Rev : 3.0-A

Changes compared to Rev 2.0-A

Texas Instruments 66/3 Bagmane Tech Park CV Raman Nagar Bangalore		
		Title CC31XX EMUBOOST		
Approval	TI	Date	Date	
Designer	TI	Date	Size A2	Project No <Project Number>
Drawn By	TI	Date	Scale	Rev 3.0-A
Layout	TI	Date	Date	Wednesday, April 16, 2014
			Sheet 1 of 3

QUAD PORT USB

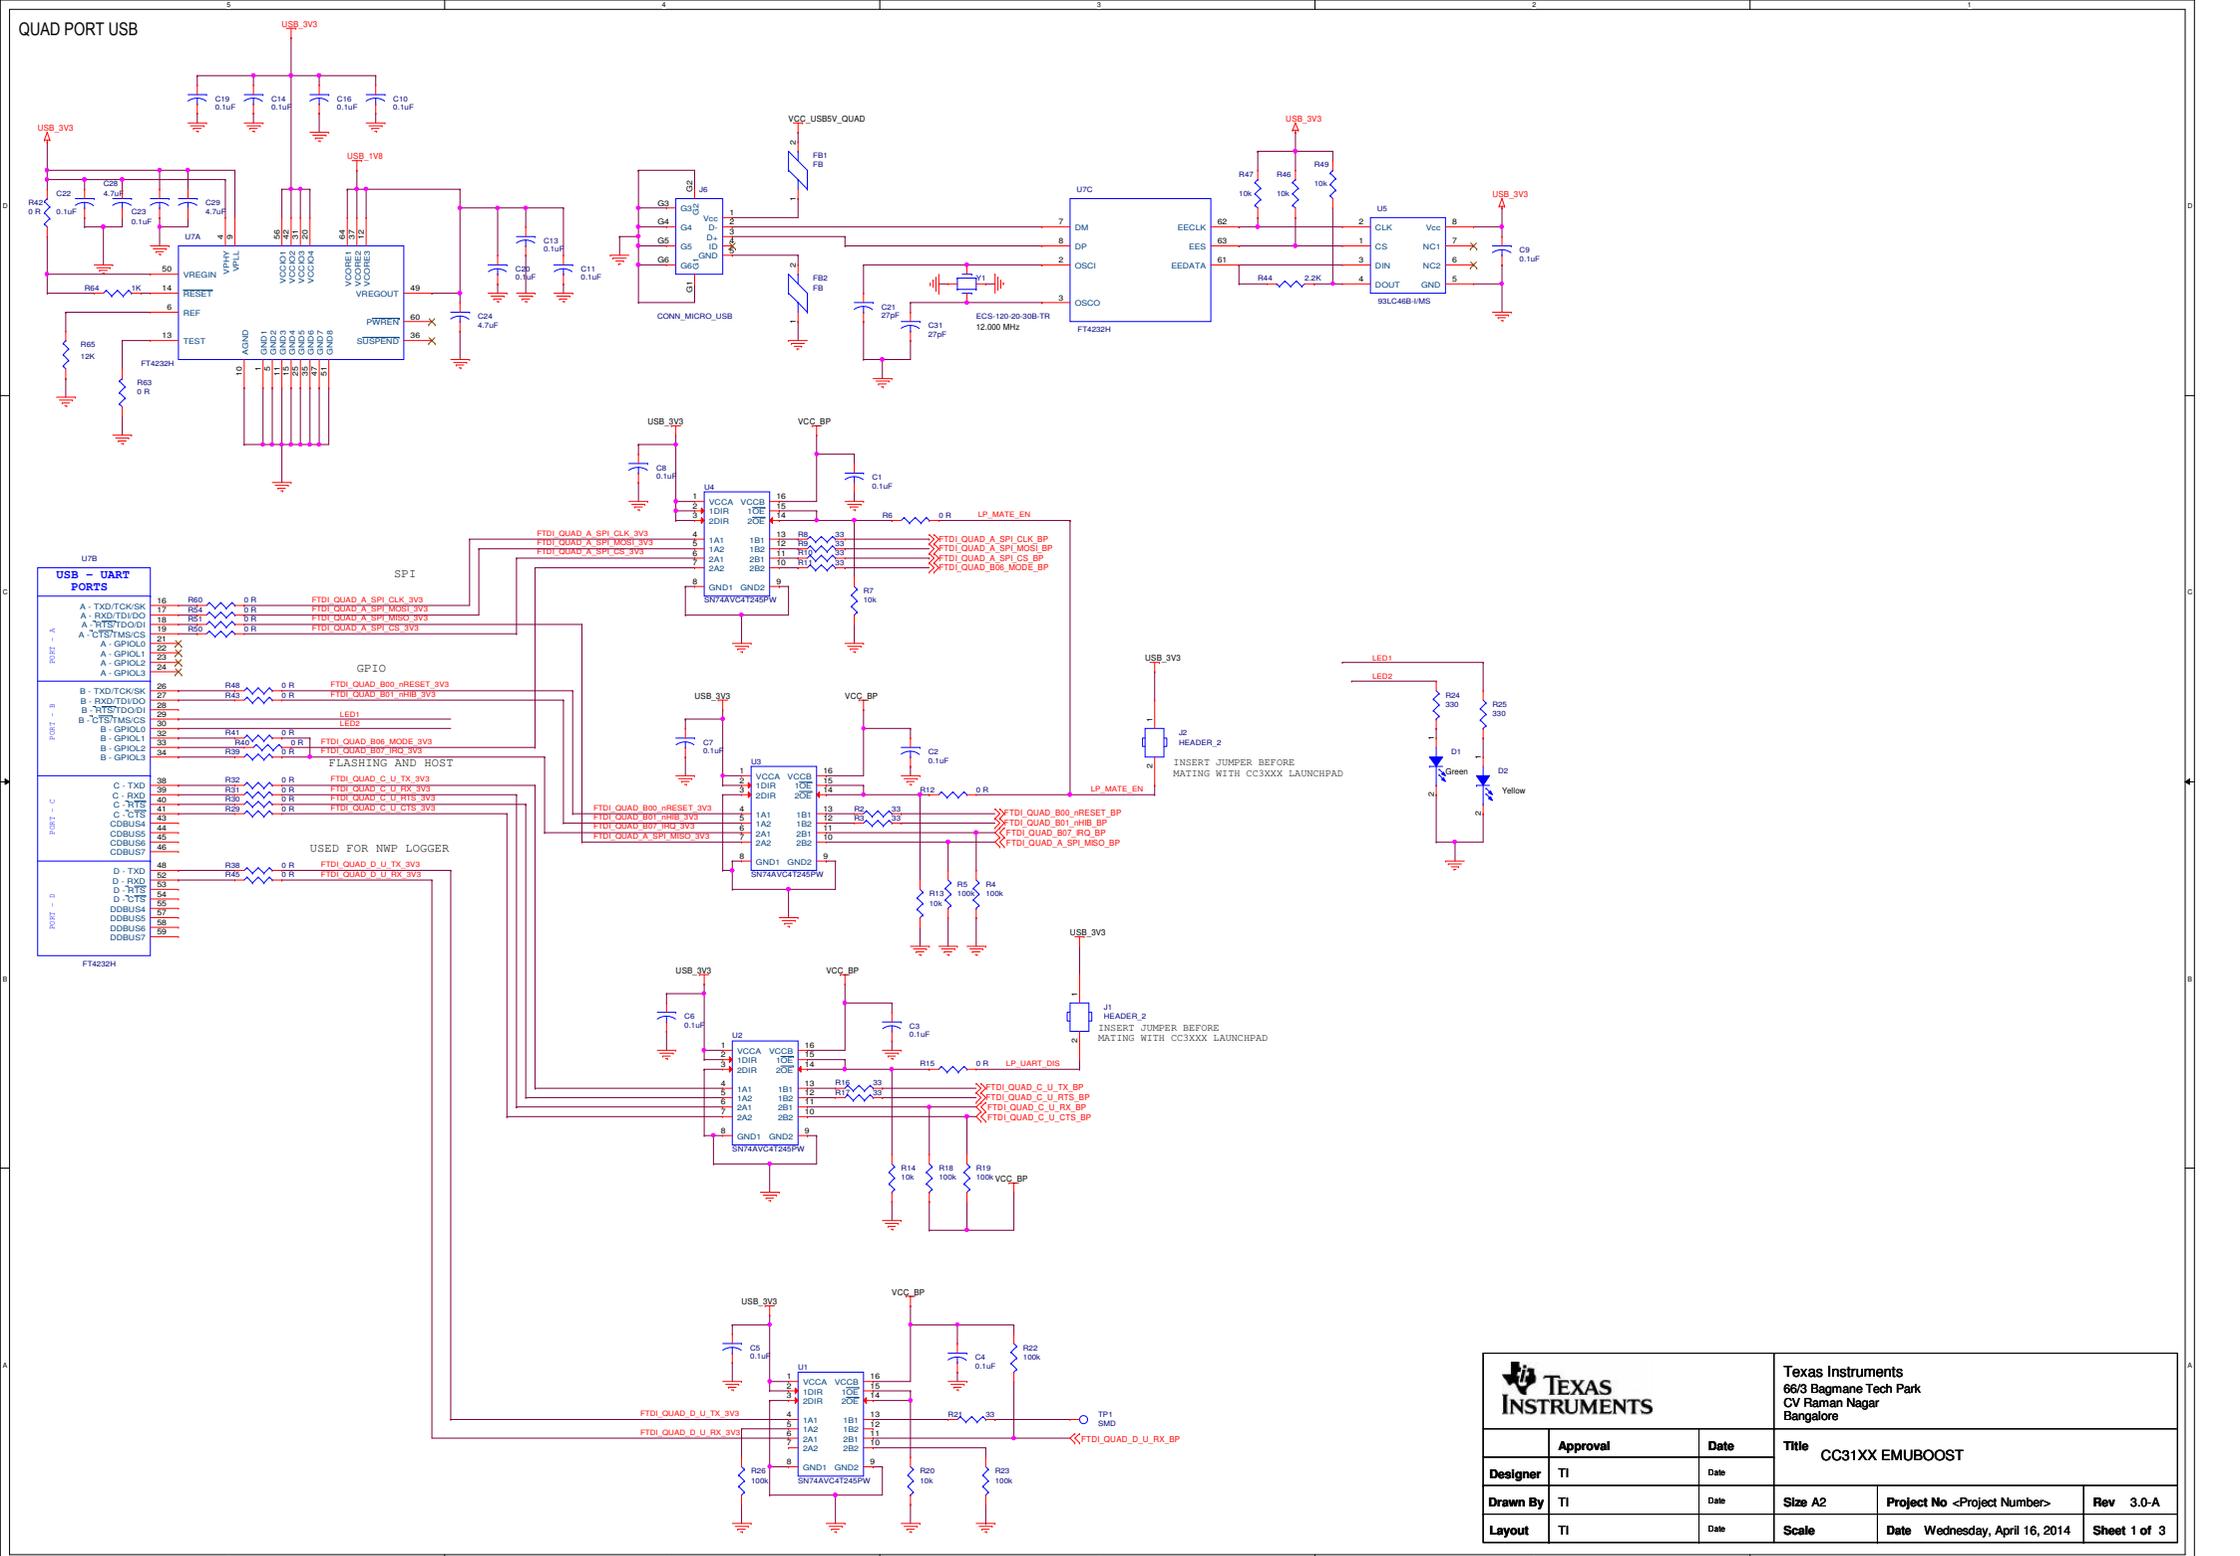
1. Swapped the SCK/CS lines for the dual FTDI (bug in design).
2. Exchanged NWP port with the RS232. Now NWP port is available on Quad UART Port-4.
3. Added option to route the NWP logger to Dual UART on LP boards.
4. Added option to flash the CC3100BP while mated on MCU LPs.
5. Added jumper to disconnect 5V when connected with LP
6. Disconnected the UART for RT3 by default using DNP resistors
